CRA Design Review Committee
Held Virtually on Zoom
Meeting Notes

Date: July 28, 2022

#### KENDALL URBAN PARK MURAL CONCEPTS AT GREEN GARAGE- 90 BROADWAY

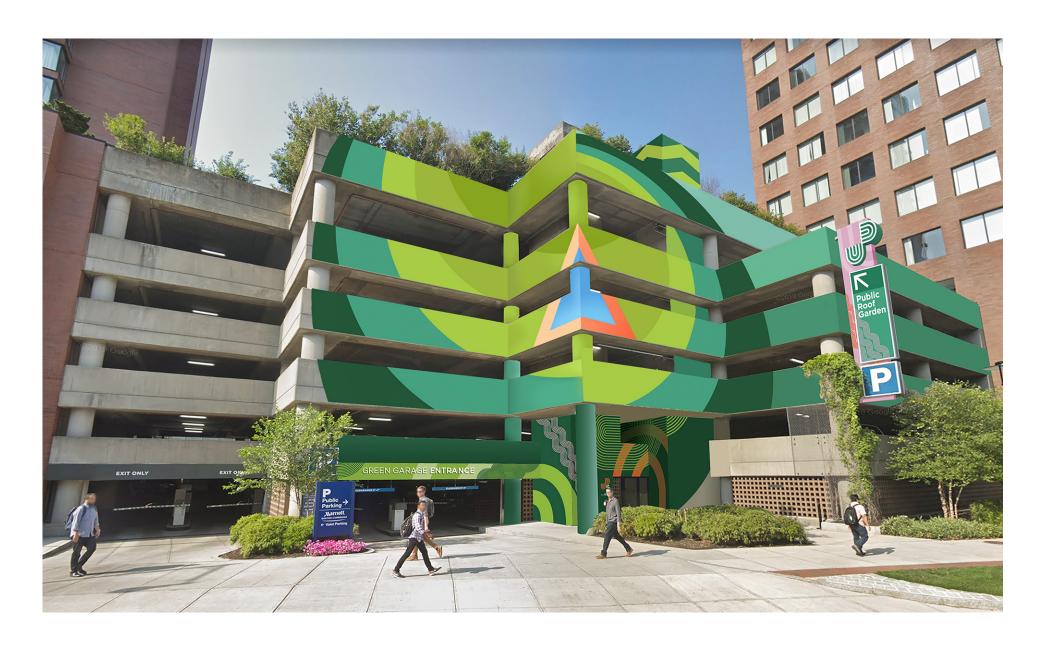
Mr. Thorkildsen noted that he liked the design, and the updated version was an improvement from the original "look" design. He suggested more emphasis on the ground level entry, the vertical shaft, and lighting to illuminate at night. He wondered if the wings of the blue shape could be lowered to form a horizontal line with the base. He asked if the entryway could be enhanced by adding planting on the concrete grid on the right side and a tree in the green area of the space. Ms. Stoddard answered that she would bring it to the BXP landscape team. Mr. Evans noted that the CRA has been working with BXP on the landscaping and that the area is currently under construction. After construction, it will be improved with new landscaping and benches.

Mr. Zevin said he has never been a fan of camouflaging buildings in paint using the building as a canvas and that it seems like too much paint that's fighting the form of the building. He said he would rather have the existing painted ivy pattern on the circular column. He continued that he reads the up arrow as a missile or target and not as an arrow. He also noted that the problem that is not being addressed is how to get people up to the roof garden. However, to get people to go up, they have to look down at the pedestrian entrance. Ms. Stoddard suggested the problem could be resolved by adding an additional chevron, messaging, or arrow to the right column. Mr. Zevin said the first two

schemes with the chevron on the elevator shaft made sense, but he still doesn't understand the desire to paint a large stretch of the garage green. He shared an example of a Sol LeWitt work at MIT.

Mr. Zevin said the form of the design on the building appeared to be a broken circle, and the entrance is caught in one edge of the circle and doesn't give any sense of belonging to the elevator shaft. He said a solution might be cutting out the circle's left side to read as a swoop up. As presented, the arrow doesn't connect to the ground floor to signify the pedestrian entrance.

Mr. Thorkildsen noted that the goal of the super graphic is to indicate where to go. Therefore, he wished the garage was different. Perhaps including vegetation that climbs up the sides of the garage or a visible stair that ascends to the roof garden. He asked if the blue and red arrow that appeared to be a fighter jet had the right message. He continued by saying if the blue and red arrow is maintained, making the round column at the first and second-floor red or blue to make the arrow appear to start at the ground. Overall, he wanted to see the garage have a positive relationship with Broadway, focusing more on design than super graphics. Ms. Finch noted that the grid area at the street level entrance was not updated because it was not part of the mural scope. She said they would like to see the red and orange area more integrated. Mr. Luke said the intention of lines, shapes, and curve elements is to draw people in, and the arrow is like a keyhole to invite people to the roof garden.

Mr. Thorkildsen said he also liked the second design and suggested painting the column below the arrow blue or red to extend it. He also noted that the issue the design is trying to solve is how to access the roof garden. He continued, saying that the current design was downplaying where to access the door instead of focusing on the entire garage. He recommended a less prominent design on the building and instead to provide more emphasis on the elevator shaft under the building where to access the door.

A public member noted that it was necessary for the design and signage to show the ultimate destination and how to get there. They also stated that the second design was better because it had less complicated shapes.

Mr. Evans asked if Ms. Stoddard could explain the chevron idea further. Ms. Stoddard said she thought the chevron could be extended down, and they would add more Urban Park brand signage and arrows at the street level to show the sign from afar. She also noted that they are working with a designer to look at vinyl or paint art on the ground to draw people to the pedestrian entrance. Ms. Stoddard shared that they would replace the scrim design to add more language directing people to the roof garden.
